204
Harvey & Marsha Brill, 204 Hessian Hills Rd. Located in a RA-40 District and designated on the Tax Maps of the Village as Section 67.20 Block 3 Lot 35.03. Request for a Wetlands Activity Permit with respect to the proposed construction of a swimming pool.

SWIMMING POOL AND LANDSCAPE PLAN FOR
THE BRILL RESIDENCE
204 HUDSON HILLS ROAD, CHOCOMCO, HUNTSVILLE, NEW YORK 10820

SECTION DRAWINGS OF PROPOSED POOL BRILL RESIDENCE

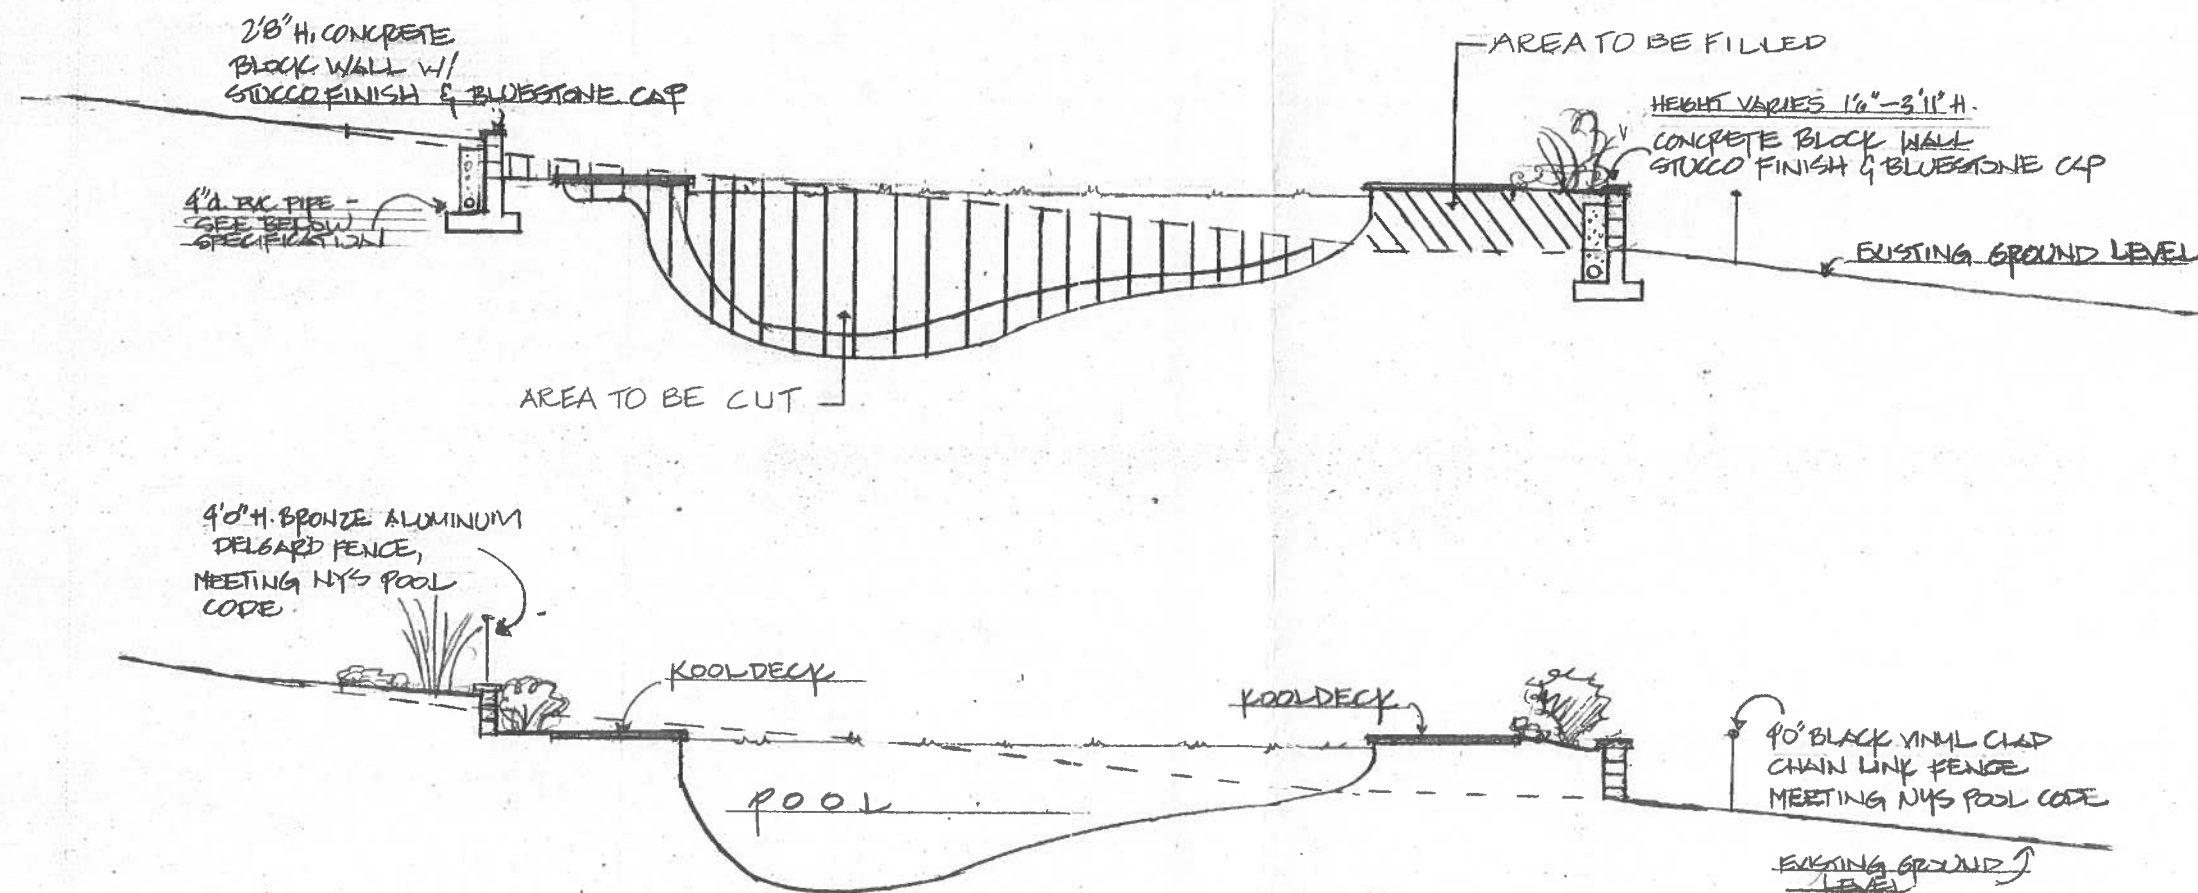
Greenbaum – How did you figure the buffer area?

Rhodes - When I visited the site I saw there was a stone wall?

Rhodes – And the septic?

Rhodes - How will pool deck and subsurface drainage be handled?

Johnsen – The engineer said that based on a satellite photo there is a seasonal stream and that is basically connected to the drains along Hessian Hills Road. That is basically the reason why we went one hundred feet from the seasonal outflow, which basically means it is in it, and if you use that criteria, everything in that area is in it including the house. There will be no backwash, it is a cartridge filter.

Johnsen – Yes. It is literally right along the stream give or take three feet and it needs to be removed because it is a hazard. I tried to be as sensitive as I could, so I pushed the pool laterally to the side. There are two trees that need to be removed. One is leaning towards the house.

Johnsen - The septic is located in the existing lawn area on the far corner of the property. That is another reason for the location of the pool.

Johansen – We are carving this side (referring to plans) two feet and on the back side of the retaining wall will be a four inch in diameter pipe and an envelope of gravel, so water that goes down the hill will hit that receptor drain (referring to plans). So, any water that comes on the decking area of the pool will go....(discussion followed over plans). There is absolutely no water that will get off this site. We are also proposing to have more plantings than there are now.
